LAVALLEE | BRENSINGER ARCHITECTS

ADDENDUM NO. 6
March 24, 2016

Re: Sanford High School and Technical Center
12-067-00

C1 CURTAIN WALL TYPE C1
A0.38 1/4" = 1'-0"

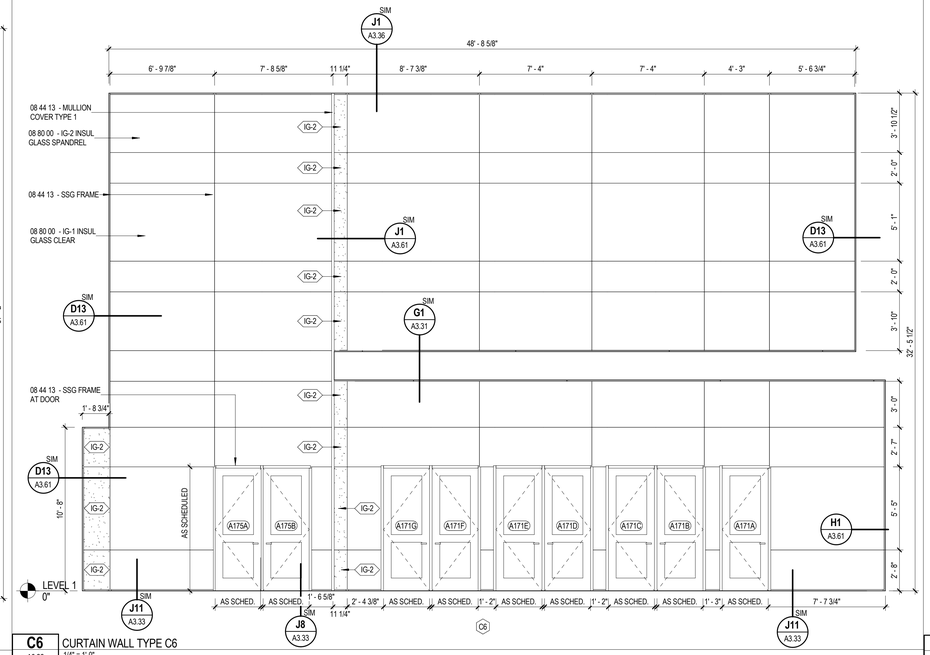
Item No. 6.1 **Reference Exterior Curtainwalls:** Question: We believe exterior curtain wall Type C1 has a structural issue that will not allow any depth 4-sided SSG mullion to be used and meet the loading. This pertains to the left side of the frame that spans a total vertical height of 32'-5 ½". Checking the structural drawings against the opening we find one horizontal tube steel at 14'-8" to top of that tube. There are two potential issues with the first being 23'-3" of unsupported curtain wall above that horizontal steel tube. The second is the tributary widths of 7'-0 ½" which are very large. This information has been verified with the basis of design manufacturer. We have a couple of suggestions one being providing another horizontal tube steel located in the center of the 23'-3" dimension. The other would be to introduce an additional vertical mullions that would align with the vertical in between the single doors. Please review and comment.

Answer: An additional horizontal tube steel will be introduced at C1, C6 and C7 at the following top of steel heights: C1 = 31'-7" AFF, C6 = 27'-9" AFF, C7 = 19'-3" above first floor. Revised structural drawings/sketches and details will be issued in Addendum 7. Specification section 08 44 13 2.02 Curtain Wall indicates a framing depth of 6 inches. Where required by the manufacturer to meet the required specified performance criteria for spans or configurations indicated by the Drawings, a 7.25" depth system will be allowed. The increased depth if required by the manufacturer or condition shall be carried in the base bid. The base bid shall include any/all frame depths, required reinforcement or other accessories and materials necessary to meet the specification performance in conjunction with the Drawing configurations indicated.

J1 LEVEL 1 - AREA C1
A1.14 1/8" = 1'-0"

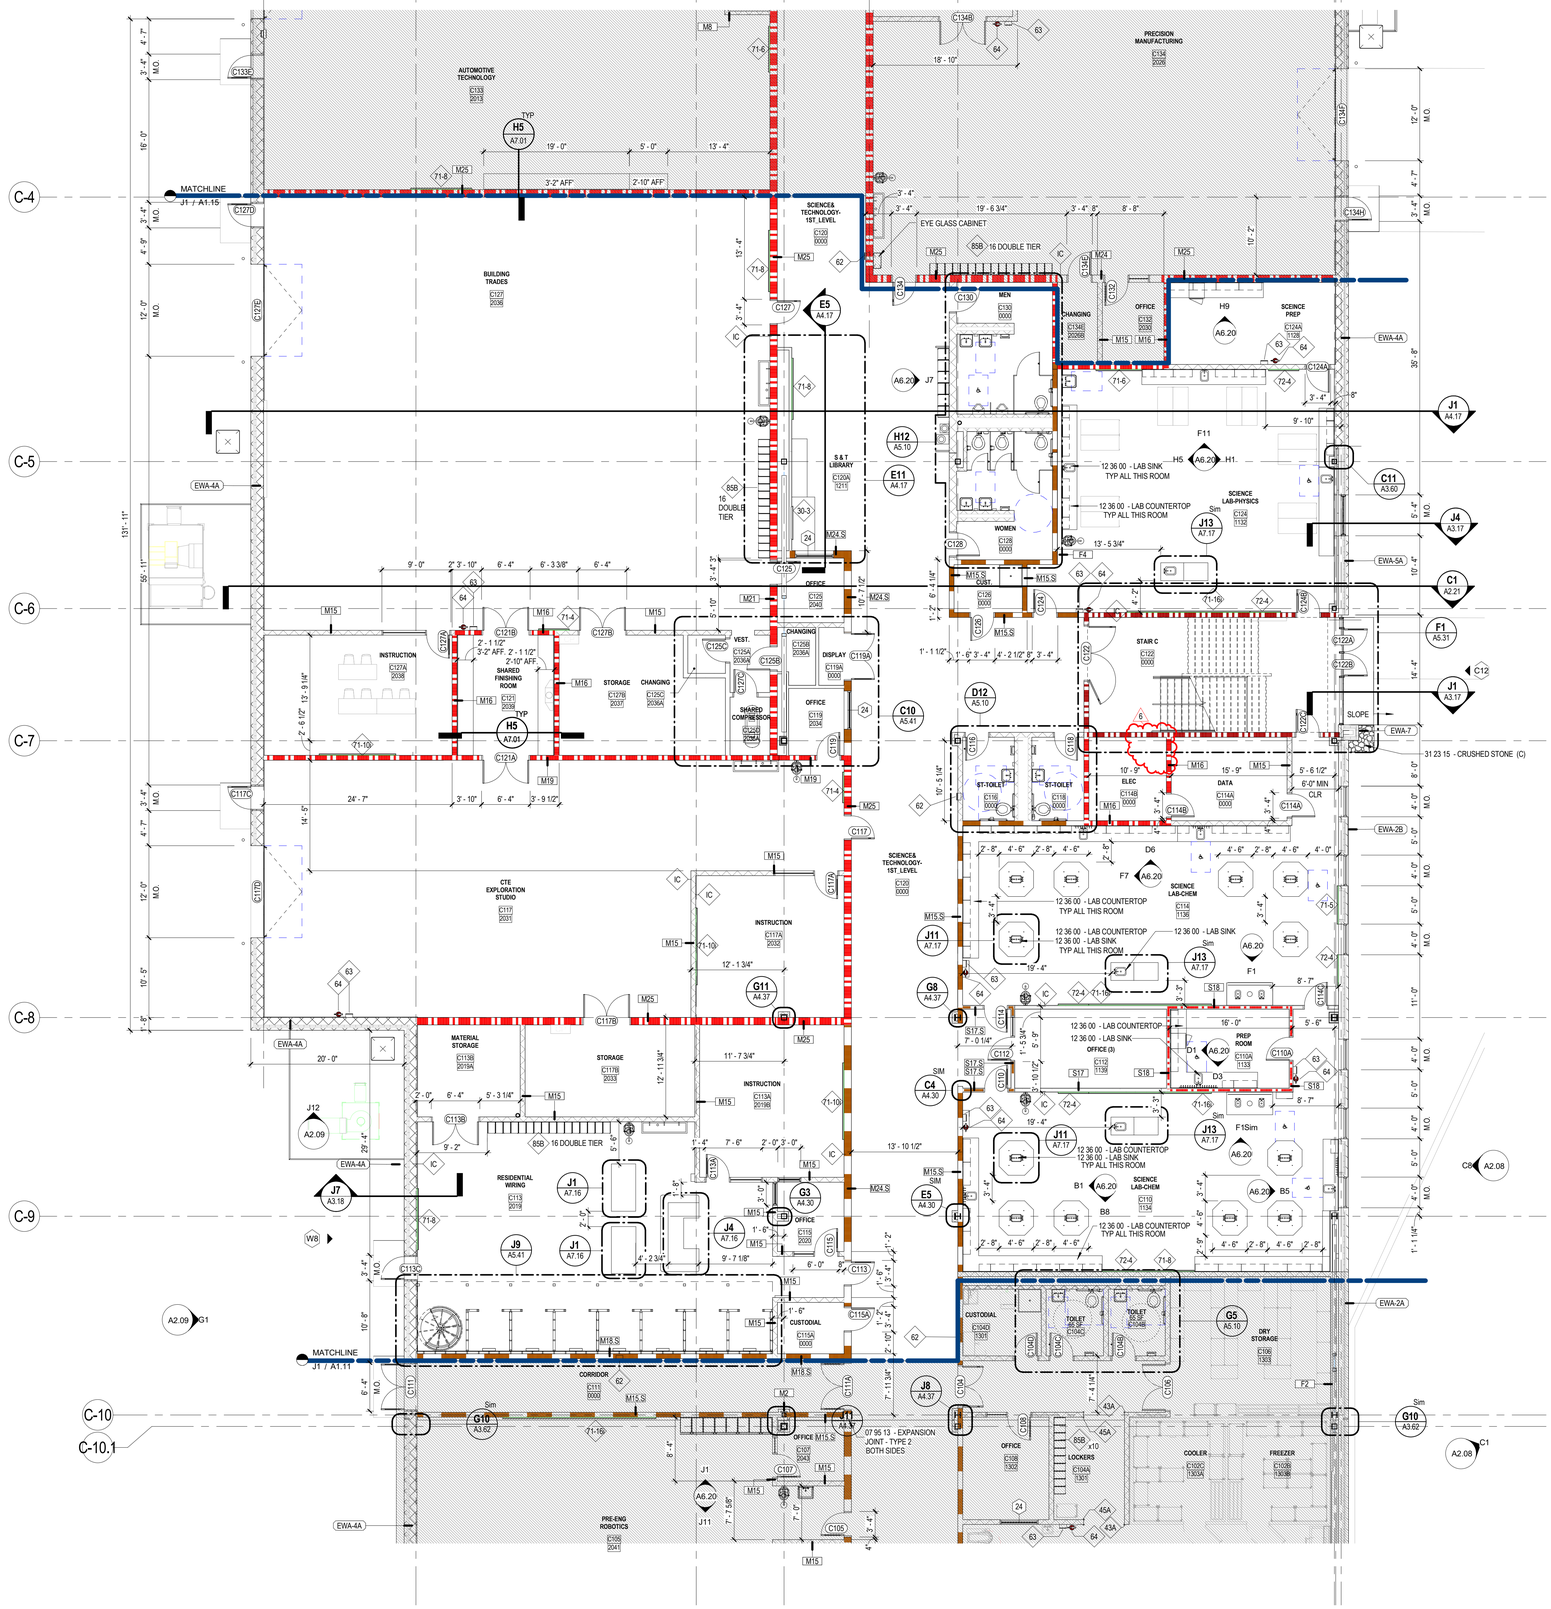
Item No. 6.77 Specification 12 34 00: Question: Reference specification section 12 34 00 – 2.06: Loose Student Tables. Please verify the location and occurrence of these tables. For example, please refer to room C124 on drawing A1.14. Are these the loose student tables? Do the other labs have these student tables? How many are to be adjustable?
Answer: There are 10 Loose Student Lab Tables in C125 (per 12 34 00 2.06A) and 2 Adjustable Height Lab Tables (per 12 34 00 2.06B) in room C124. These are the tables shown on A1.14. This is the only location for these tables.

J1 LEVEL 2 - AREA A3
A1.22 1/8" = 1'-0"

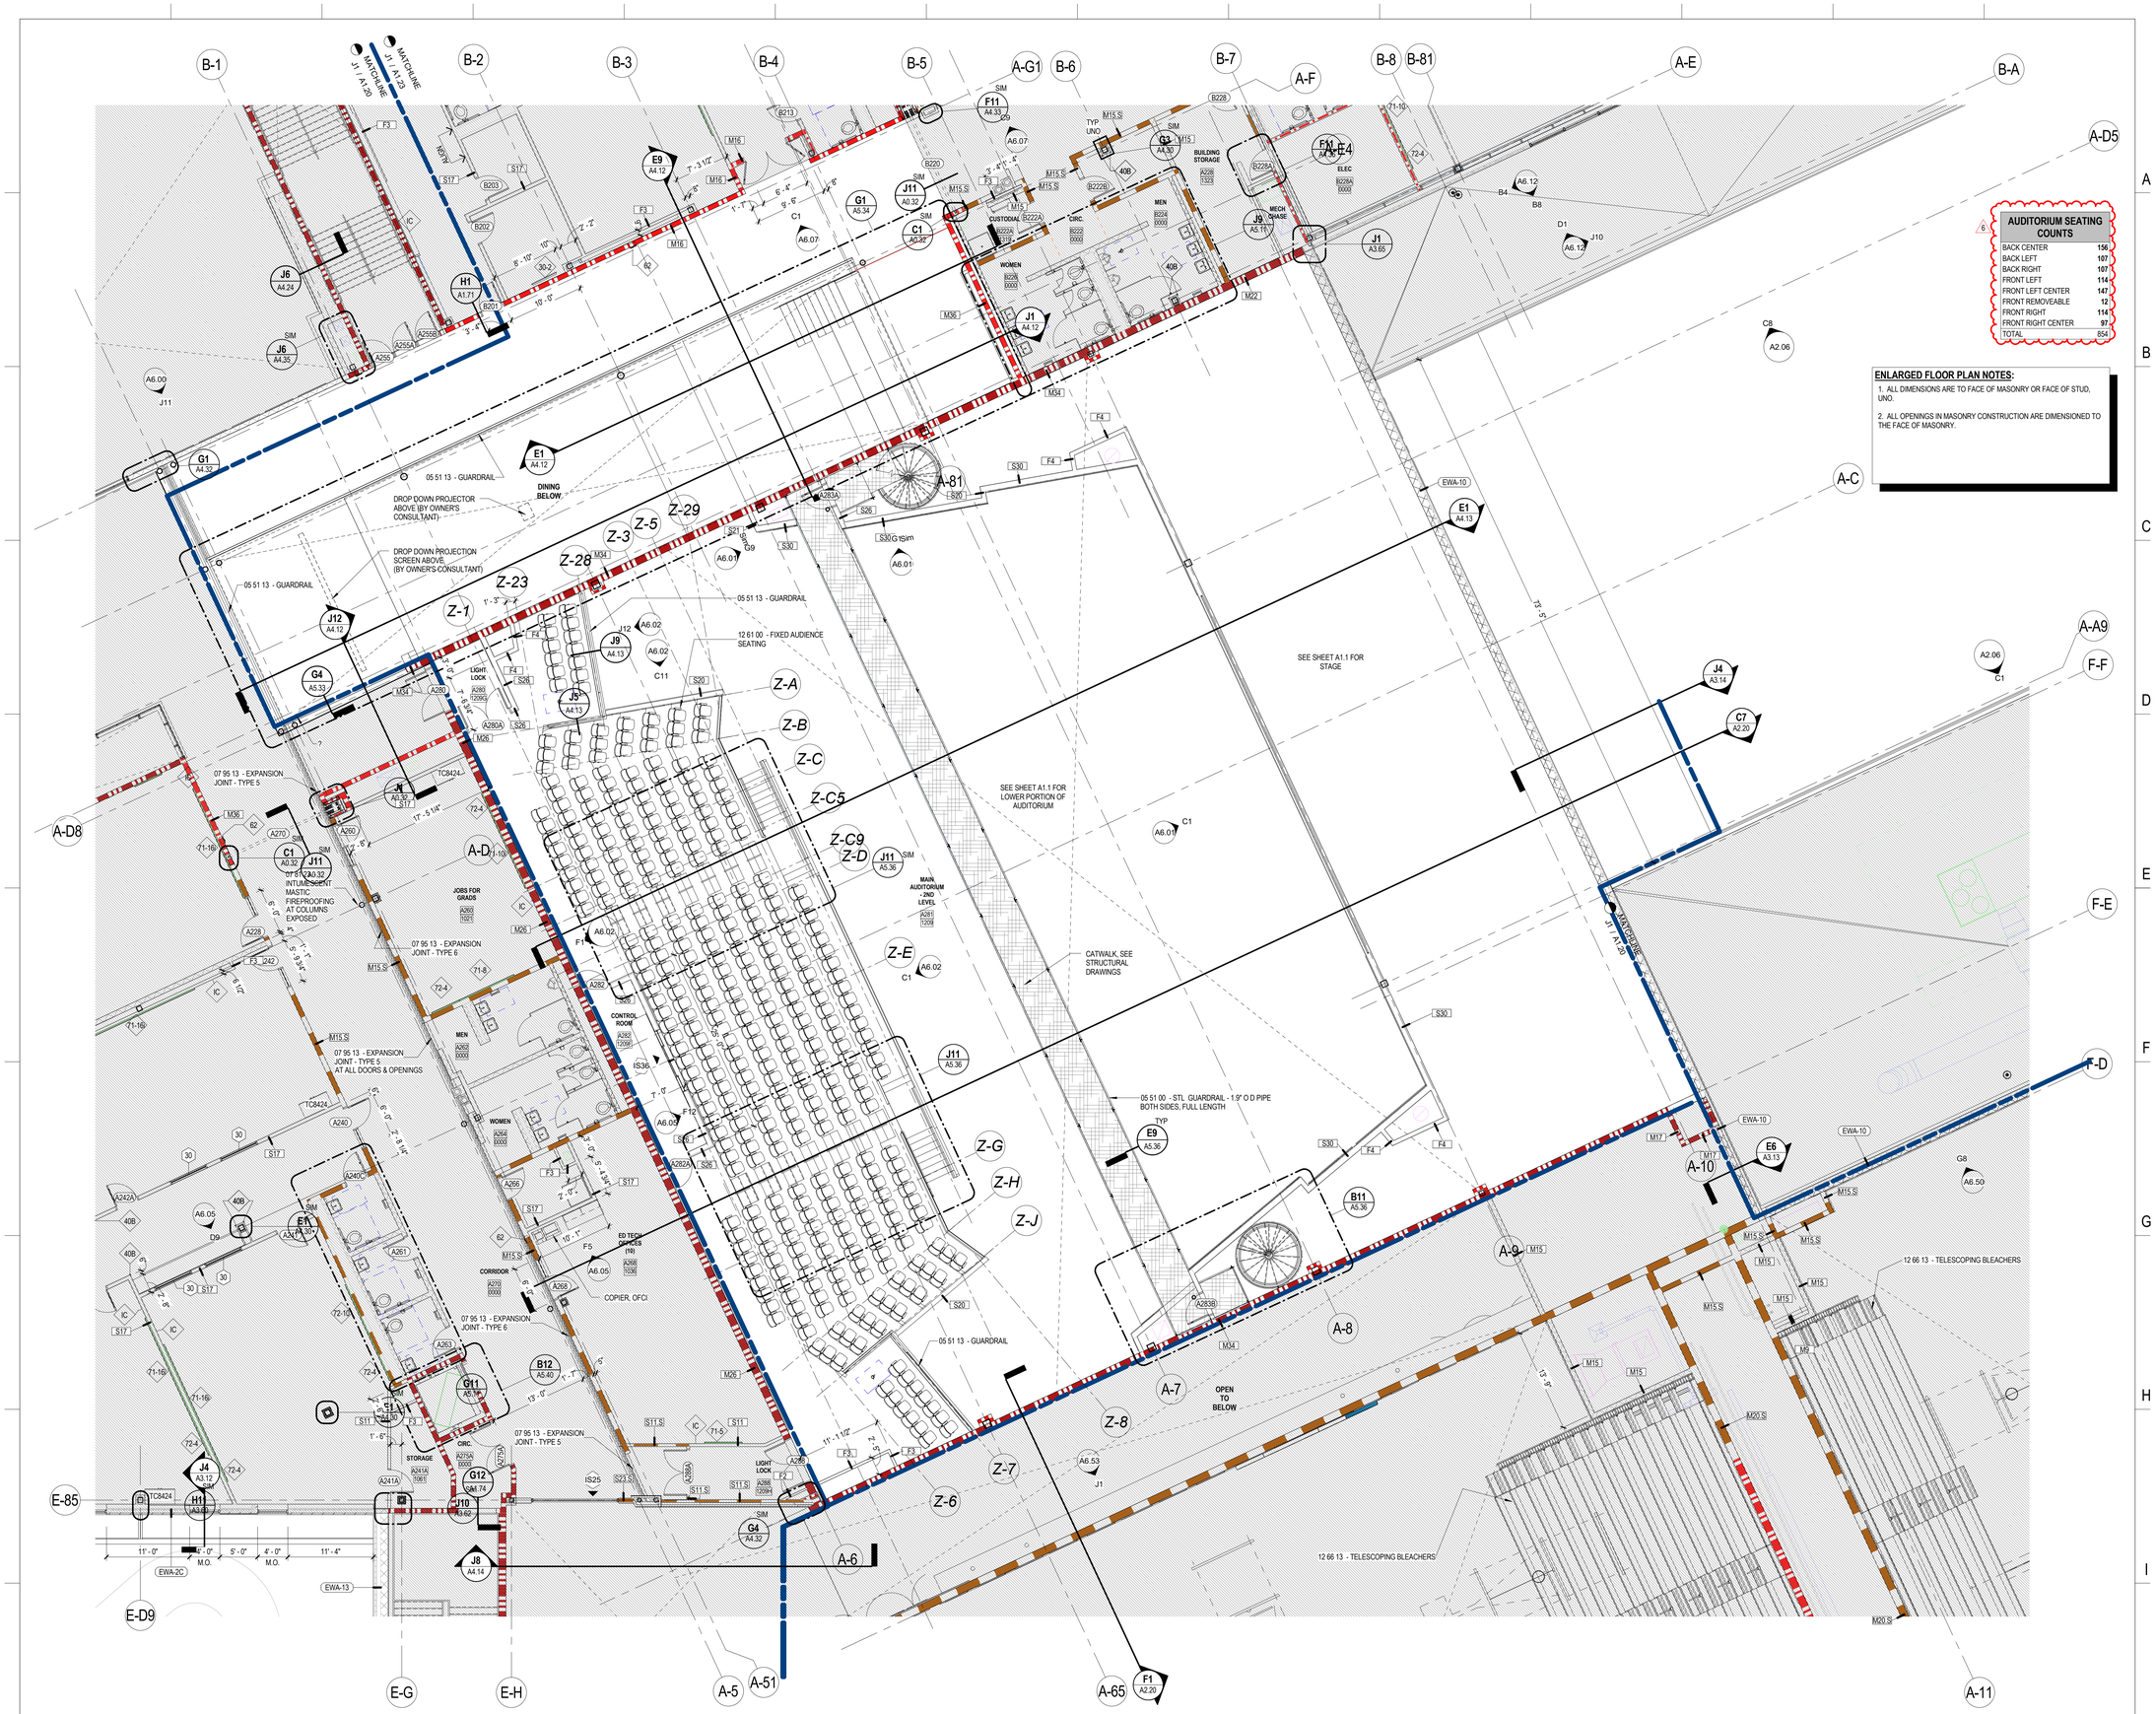
Item No. 6.45 Reference Drawing A1.12, A1.22: Question: The North and South walls of the Auditorium (Column Lines A-E and F-E) are labeled as wall types M34. Please confirm that the Ground Face of these walls will be towards Rooms A121A and F101 and that the Auditorium CMU is to be painted (therefore does not need to be ground face).
Answer: The auditorium is painted (therefore does not need to be ground face). See also response to Item #6.32.

Item No. 6.54 Reference Drawing A1.12, A1.22: Question: Please confirm the bleacher seat count as the physical seat count on drawings A1.12 and A1.22 does not reflect the seat count called out on the legend shown in the upper right corner of each drawing.
Answer: There are no "bleachers" on A1.12 and A1.22. However, the Auditorium fixed audience seating count in the legend and seats shown have been corrected to align. Refer to the attached revised drawing A1.12 and A1.22. The seat count does not include wheelchair seating locations.

J1 A1.23 LEVEL 2 - AREA B
1/8" = 1'-0"

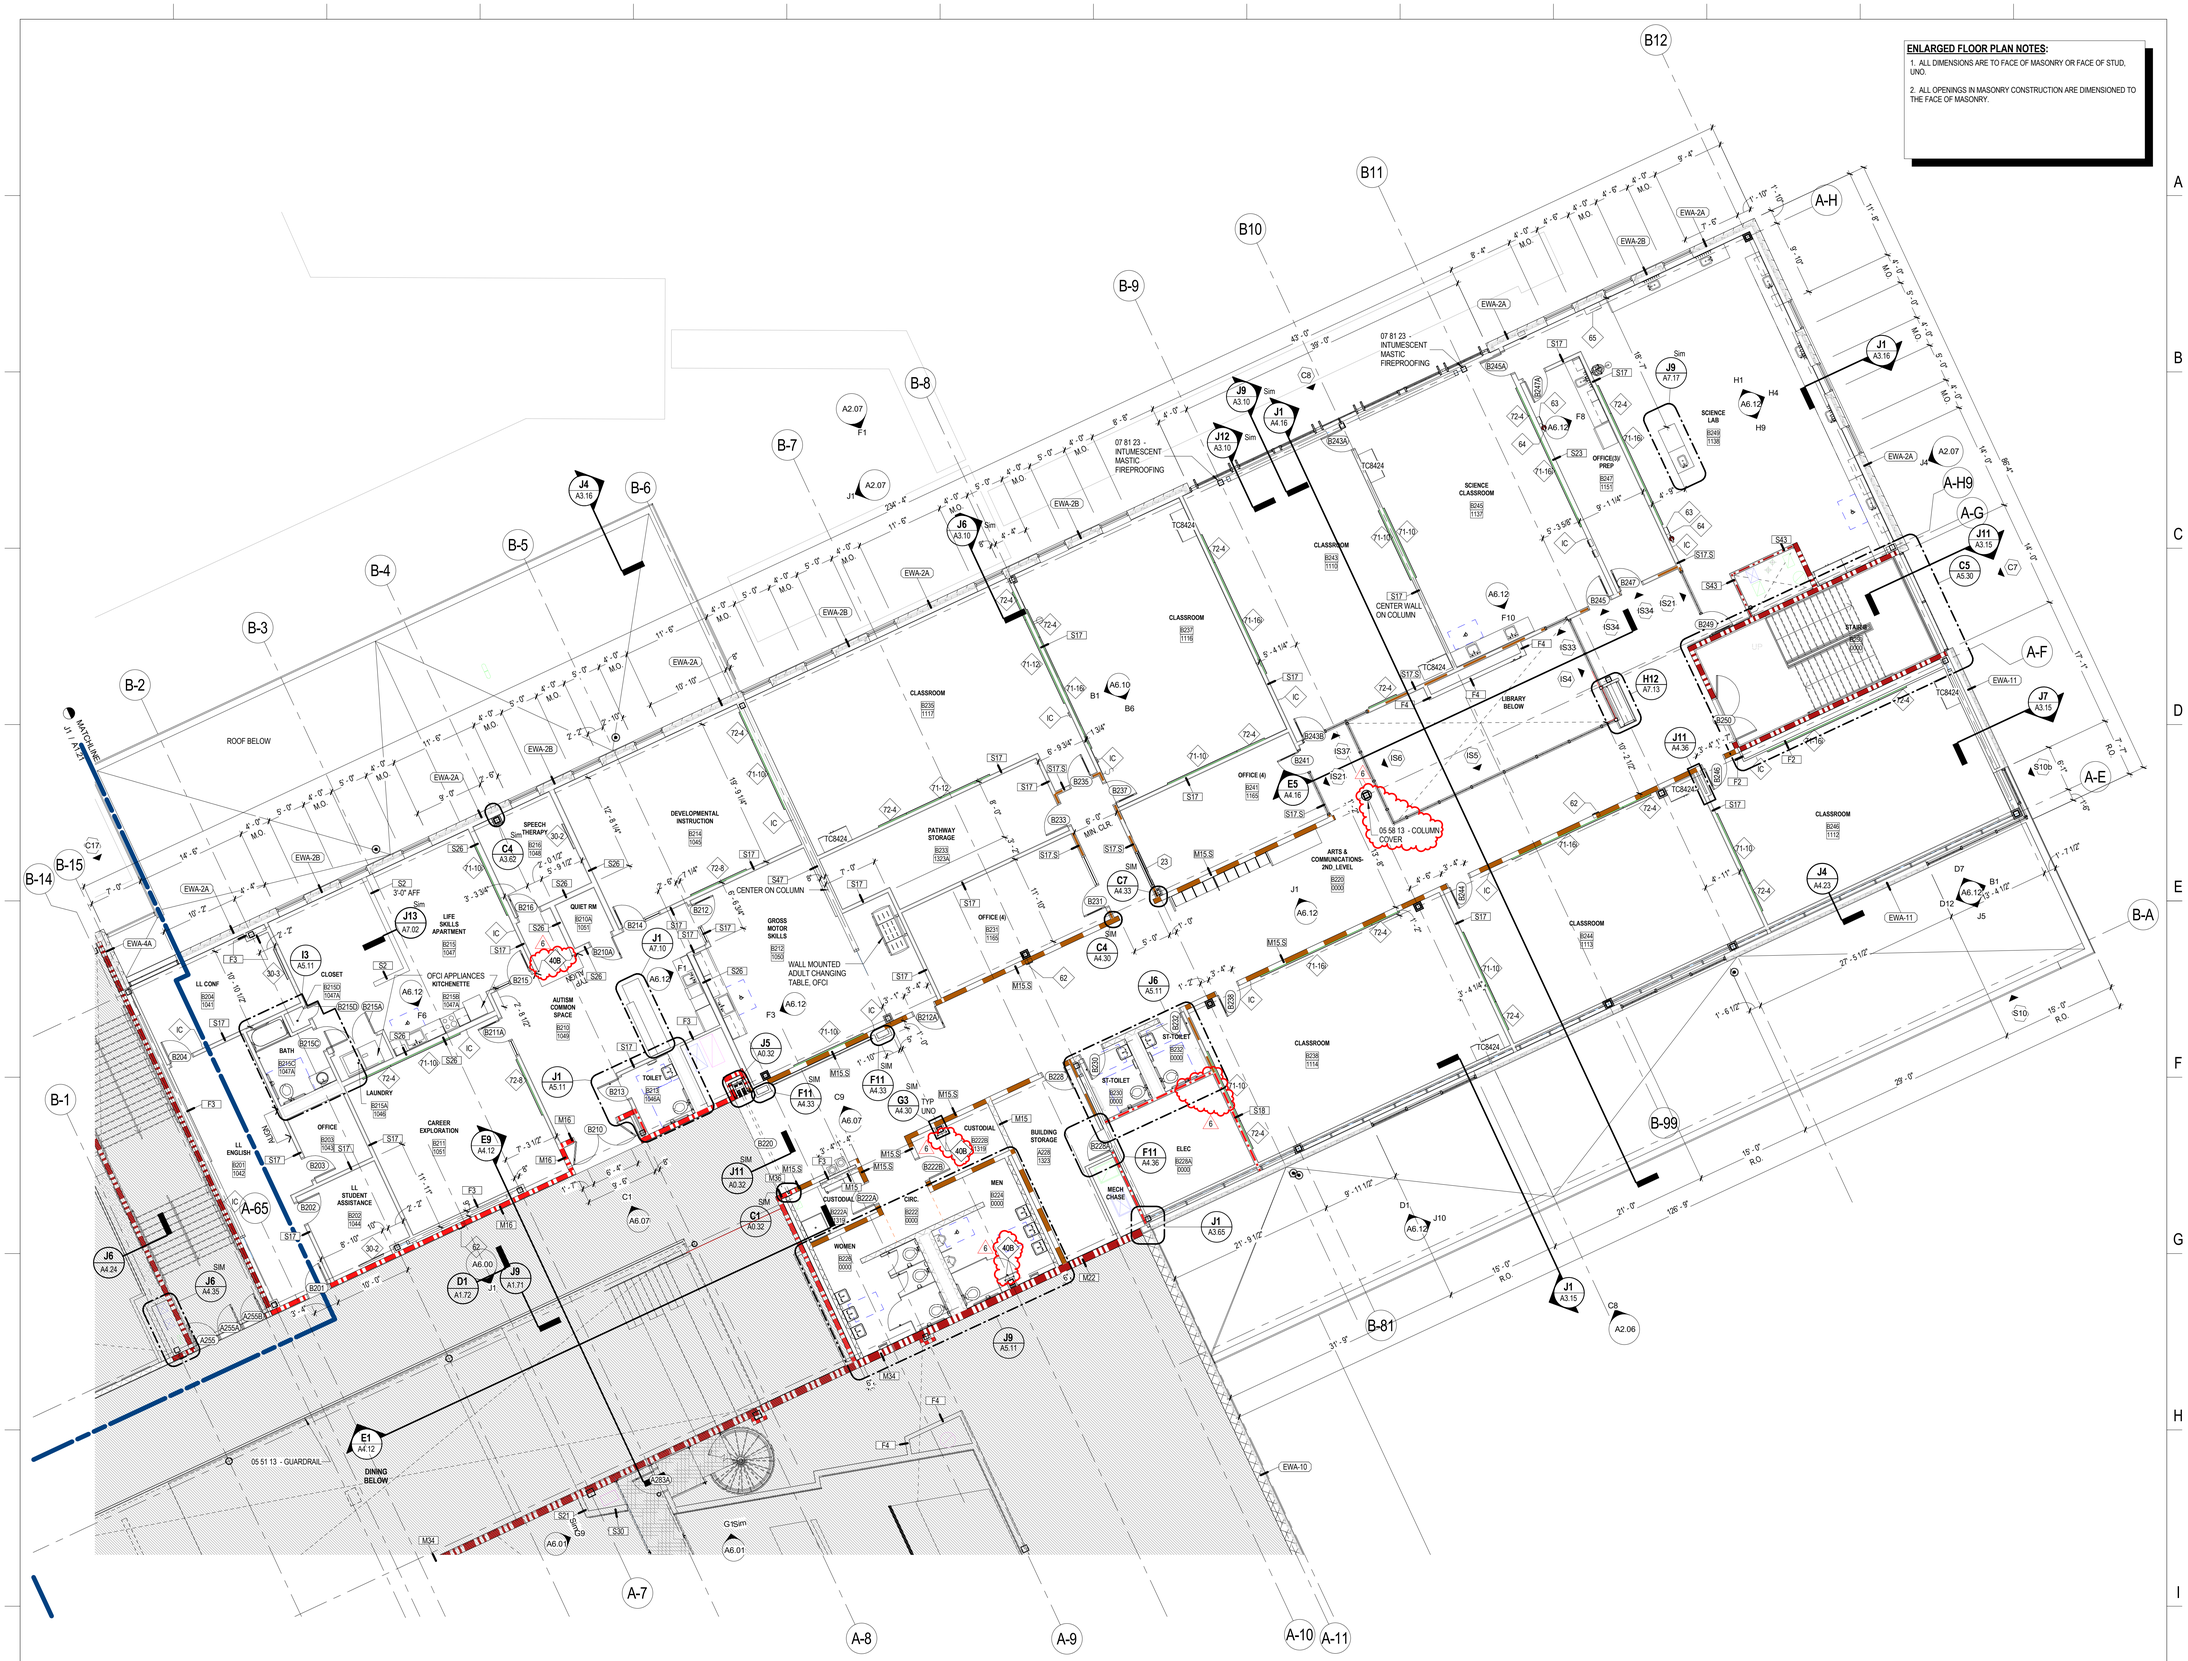
Item No. 6.51 Reference Drawing A1.23: Question: Just inside door B245 there are two wall hung specialties without a designation. Can you please provide information on these items?
Answer: Delete these two specialty items with no designation.
